LVD Timing Diagram Correction

SPI-3R2 Figure 44 & 45 correction

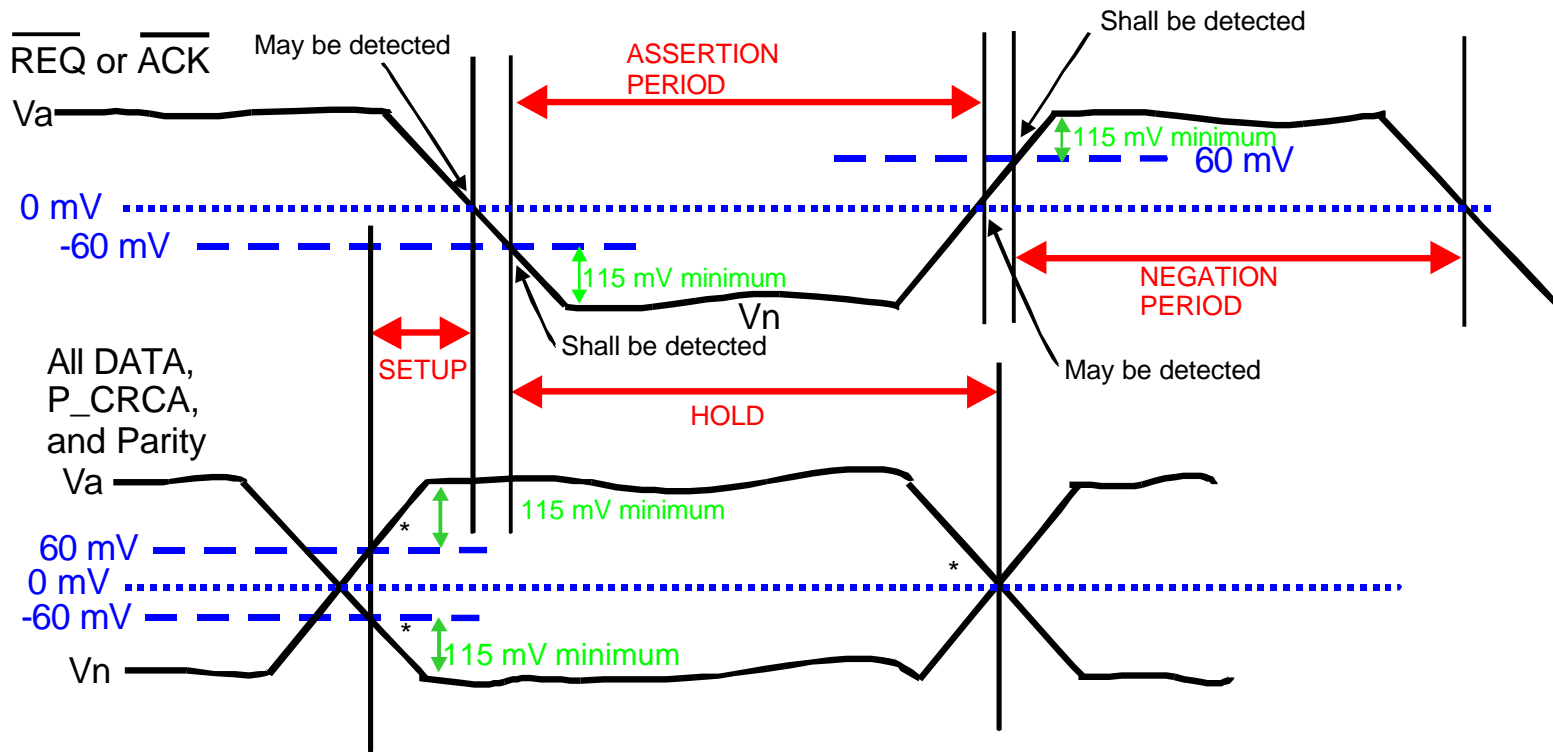
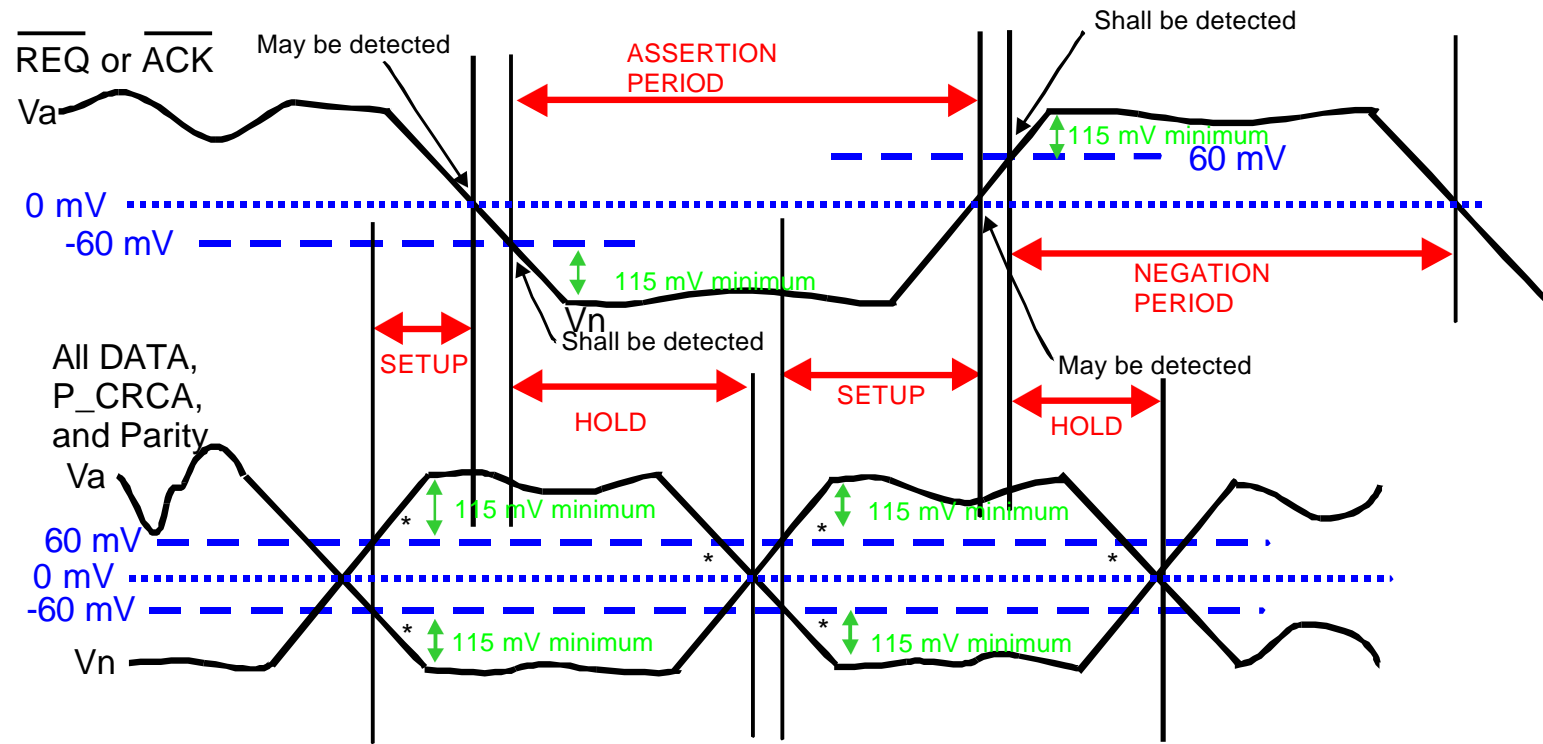
Driver Level Issues

Receiver Requirement

- The receivers require over drive to switch fast enough to not have skew problems.
- The receiver overdrive is not a function of the previous voltage, but a fixed 115 mV over the 60 mV AC threshold.
- AC measurement may switch is not 60 mV, it is 0 mV.

* Use the crossing that yields the shorter SETUP and HOLD Time
 V_a or V_n must over drive the 60 mV threshold by 115 mV at the leading edge of the transition.
 V_n = Negated Signal
 V_a = Asserted signal
 Differential voltage signals in all Cases

* Use the crossing that yields the shorter SETUP and HOLD Time
 Va or Vn must over drive the 60 mV threshold by 115 mV at the leading edge of the transition.
 Vn = Negated Signal
 Va = Asserted Signal
 Differential voltage signals in all Cases
